Sub :- TSFD- Forest(C) Act, 1980- Diversion of 3.412 Ha (revised from 4.654 Ha) of Forest Land for Construction of BT Road from **Govena to Jambuldhara** from Km 0/0 to 9/400 via Sidamguda, Nagaguda and Maraguda village of Lingapur Mandal, Tiryani and Kawal RFs of Asifabad Forest Division of Kumuram Bheem-Asifabad District under LWE (RCPLWE) in favour of Executive Engineer, R&B Division, Asifabad- **Additional information sought for by IRO, GOI- Submitted** - Regarding.

Sub: Diversion of 3.412 ha (revised from 4.654 Ha) of FLinAsifabad Division for Construction of BT road from Govena to Jambuldhara ~~to Loha~~ from km 0/0 to 9/400 via Sidamguda, Nagaguda and Maraguda village of Lingapur mandal, Tiryani and Kawal TF's of Asifabad Division, Kumrambheem Asifabad District- in favour of Dist R&B Officer, Kumrambheem Asifabad District- Submission of Additional Documents/Clarifications-Req-Reg.

Cross Section Details

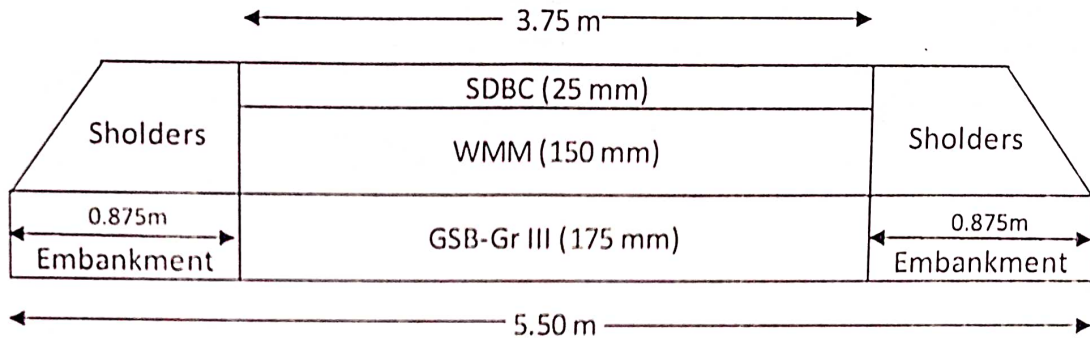
Design/cross section of the proposed road clearly indicating the width of carriage way (BT portion), shoulders/ Berm / drainage etc may be furnished.

Reply: Road designed with CBR 4.03% and Traffic (T3). And below cross section will explain width and thickness of carriage way (BT portion), Shoulder/Berm/Drainage.
